City of West Linn
PRE-APPLICATION CONFERENCE MEETING
SUMMARY NOTES
August 20, 2009

SUBJECT: Two site plan alternatives for a mixed use retail commercial/multi-family development at 1575 Burns Street

OBC PLAN MASSING STUDY
WEST LINN PROPERTY
RALF OLSON
ROBERT H. FOSTER CONSULTANTS
431 ASH ST., LAKE OSWEGO, OR.
97034 (503) 635-6190

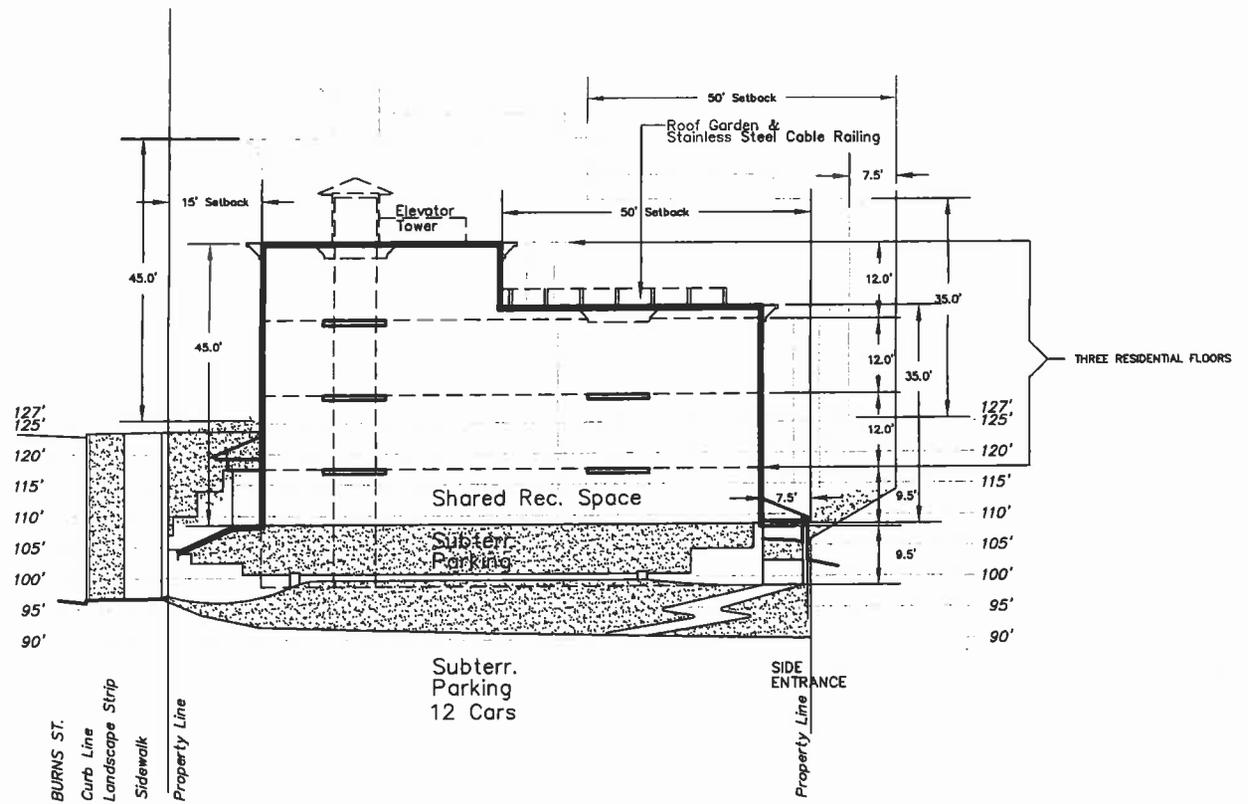
One possible site plan concept involves two mixed-use buildings, each with non-residential uses on the first floor and multi-family residential on the three upper floors. One of these buildings would be located at the northeast corner of Hood and Burns; there would be a parking lot east of this building separating it from the other, similar building also located on Burns Street. The western of the two buildings is proposed to have commercial on the first floor; the eastern of the

two is proposed to have the shared recreational space required for multi-family projects on the first floor. The main entrance for each building would be on its respective west side, meaning that for the building with commercial uses on the first floor, the main entrance or entrances would face Hood Street, continuing a street-frontage-oriented commercial atmosphere north from West Linn Central Village.

Towards the northern half of both buildings, only two upper floors are proposed due to the provision in 21.070(A)(7) that further limits the height/number of stories for OBC zone development within 50 feet of a low-density residential zone. In this scenario, Hood Street would be considered the front of the development, allowing for the building frontage to have no setback on Hood Street, continuing the existing village-style commercial atmosphere from the south. In this conceptual plan, there would be parking under both buildings. The eastern of the two buildings would have a driveway accessing the ground floor garage off of Burns Street to the south. The western building would have a driveway from the parking lot to the ground floor garage. This plan, as with the other plan discussed below, needs a PUD application in this zone per CDC 24.060(B)(2) as more than 20% of the dwelling units are to be attached on common wall. It is unclear whether more or less than 25% of the site consists of 25%+ or more slopes (which are Type I and II lands). If more than 25% of the site consists of these lands, this in itself also triggers the PUD requirement per 24.060(B)(1)

The monolithic nature of the buildings in this conceptual plan, the fact that they are even closer to the residential lots to the north than those in the other plan, and other issues all raise serious concerns about the even the most basic acceptability of this plan. The other site plan, relatively speaking at least, is favored by staff between these two.

MODIFIED CONCEPT LAYOUT PLAN
WEST LINN PROPERTY

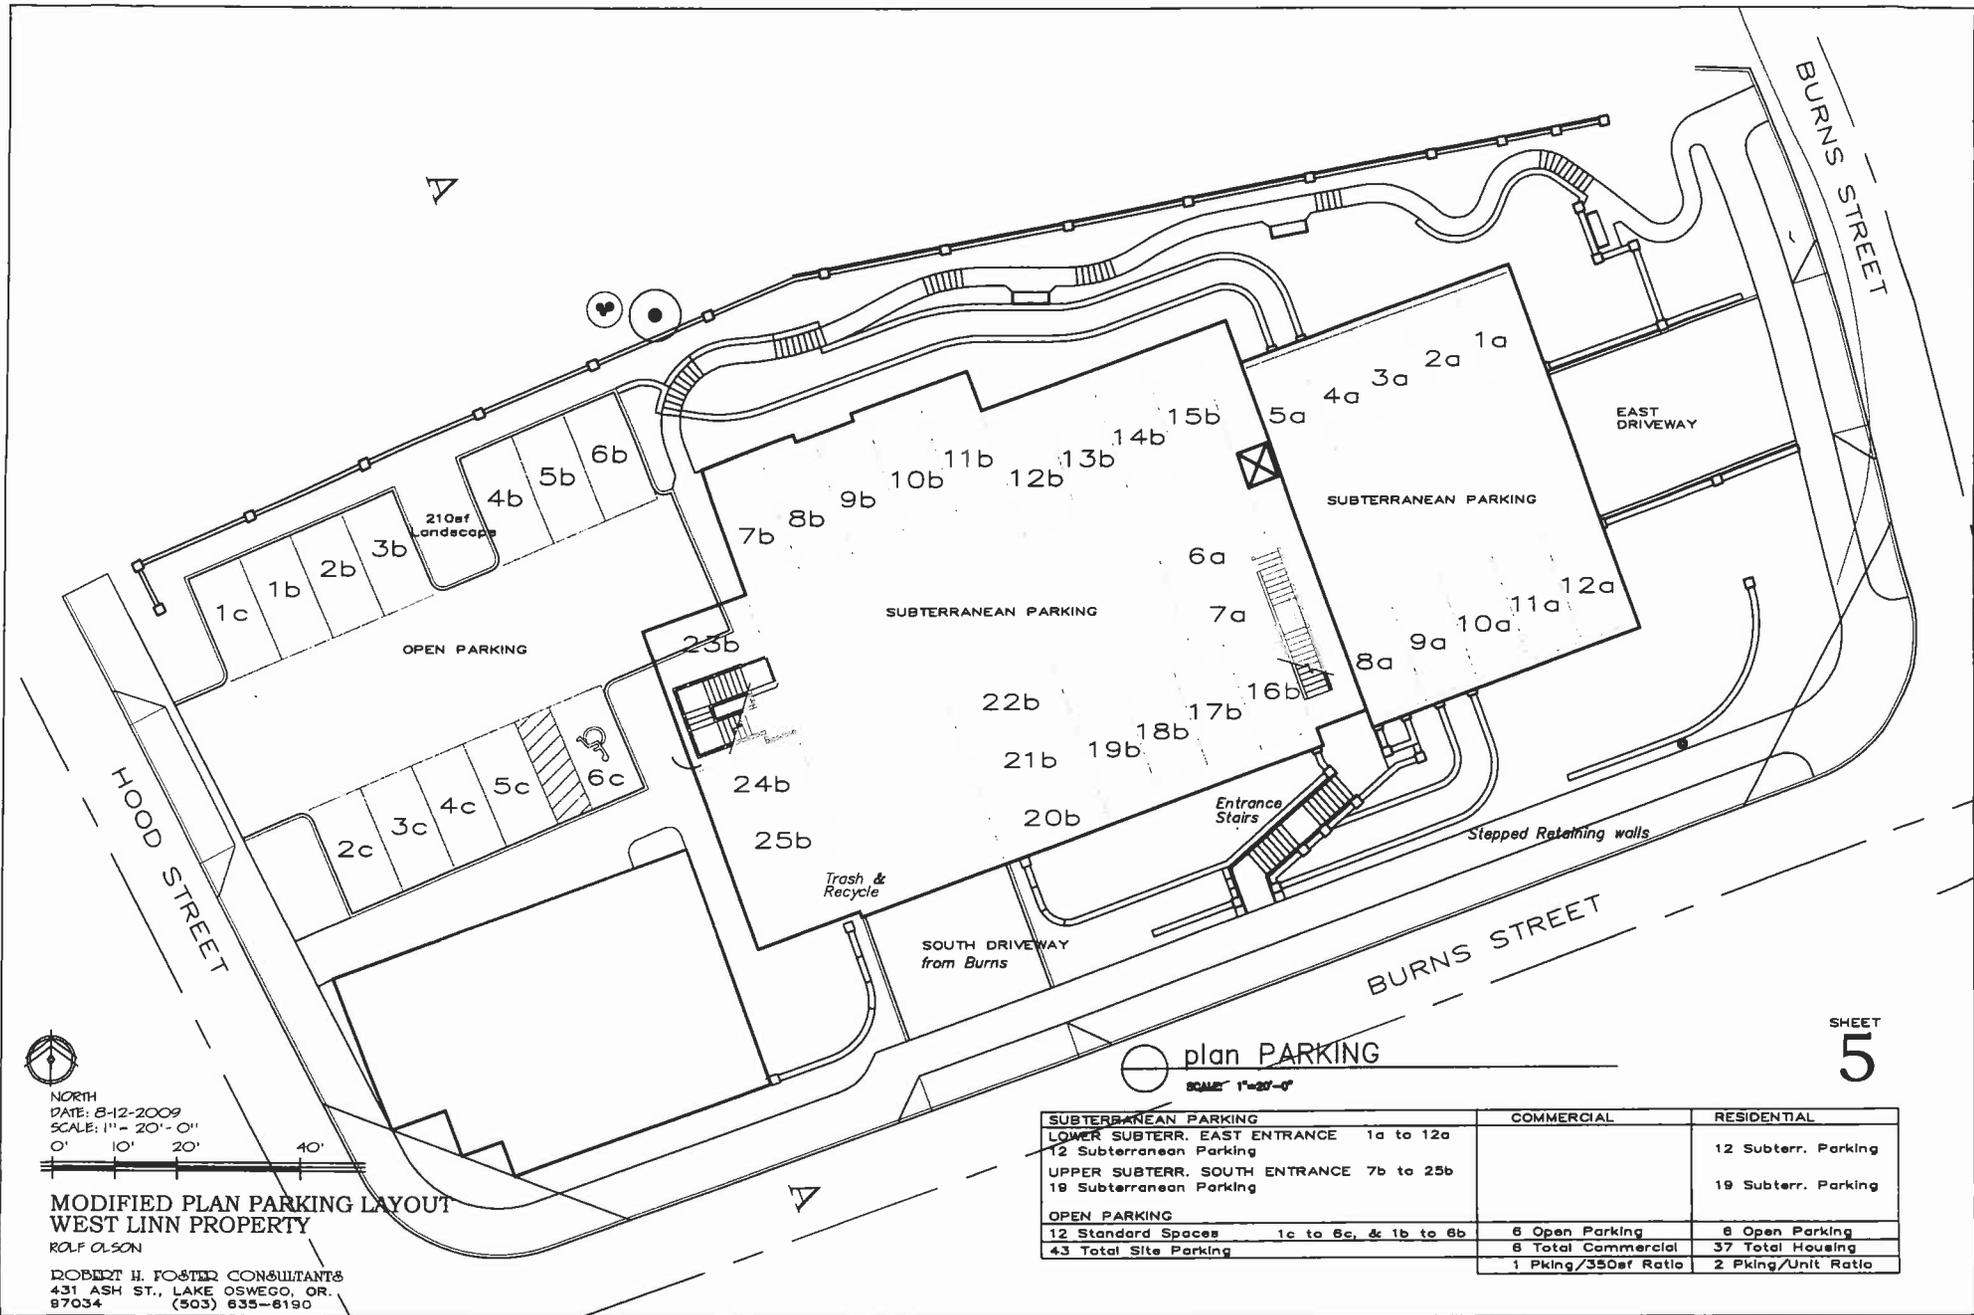
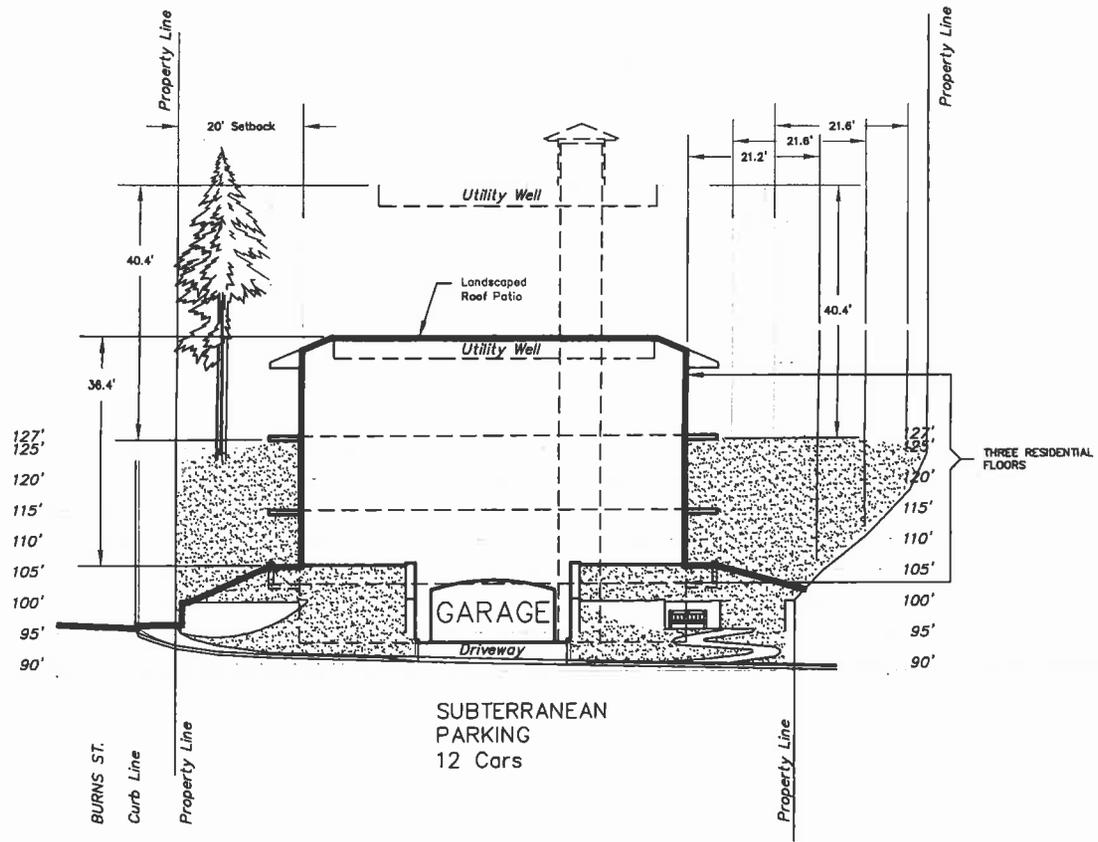
The other conceptual plan involves a smaller one-floor commercial building at the northeast corner of Hood and Burns and a larger set of residential buildings to be built to the east, following Burns Street from the western plateau of the site down the hill to the site's east end. In the OBC zone, the development of residential and commercial buildings in separate buildings in a development is only possible through the PUD process, as non-PUD OBC developments only allow for multi-family residential on the upper floors above first-floor commercial. As discussed above a PUD is required anyway since all units are attached via common wall. In this plan, the main entrance for the commercial building will be on the north side facing the parking lot, the main entrance for the western of the two residential buildings will be on the west side facing the same parking lot, and the main entrance for the eastern residential building will face Burns Street.

Under this conceptual plan, some parking will be surface parking (accessing from Hood Street) north of the commercial building and west of the residential buildings, and some parking for the multi-family units will be provided in the ground level of each residential building, with driveways to the underground garages taking access from both the east-west and north-south segments of Burns Street. A trail is also proposed on this conceptual plan, linking the surface parking lot on the west end of the site to Burns Street at the northeast corner of the site, via the north side of the residential buildings.

Under this plan, the applicant considers the eastern one-third of the residential complex within the site to be a different building than the western two-thirds of the residential complex, with the two adjacent to each other only via the exterior hallway and elevator shaft. This theoretically will allow each of these two individual buildings to have its own height measurement; this conceptual plan would not meet code per height (or would need a height variance) if the entire residential complex was to be measured from the very bottom to the very top. Whether or not these can count as two buildings may be open to the interpretation; however separating them as two buildings that do not touch would be the way to ensure that height would even possibly be measured separately for the two buildings by the Planning Commission. Considering them to be two different buildings, even if it is deemed acceptable by decision makers in relation to the definitions of “building”, “height”, or other appropriate terms, may be problematic in terms of meeting at least one criteria in 55.100, which is 55.100(B)(5) which states, “There shall be adequate distance between on site buildings and on site and off site buildings on adjoining properties to provide for adequate light and air circulation and for fire protection.” And beyond even this particular code section, this agglomeration of relatively large and looming buildings going down the hill on this site may raise concerns regarding compliance with more subjective Chapter 24 and Chapter 55 criteria related to the appropriateness of the proposal to the site and the surrounding neighborhood.

Applicants are allowed to propose alternative setbacks as part of the PUD process, per 24.180(D)(6). The second conceptual plan proposes an alternative rear setback (20 feet instead of 25) for the eastern of the two residential buildings and an alternative side street setback (0 instead of 10) for the commercial building along the Burns Street side; this allows the building to imitate the village style commercial development to the south along both its frontages instead of just one.

The applicant also appears to propose a property line separating the commercial building and the multi-family buildings on the second and preferred conceptual plan. This would require a minor partition application as well as the other applications discussed above. While dividing the commercial and multi-family units into separate lots may be acceptable in of itself if all appropriate access and parking easements are established, staff would not be able to support the zig-zagged property line as proposed per 85.200(B)(6). If the lot is partitioned more alternative PUD setbacks would have to be proposed as if the commercial building is against the property line to the east as shown on the preferred plan. If the partition is applied for, all other provisions of Chapter 85 will have to be met as well, including all criteria in 85.200.
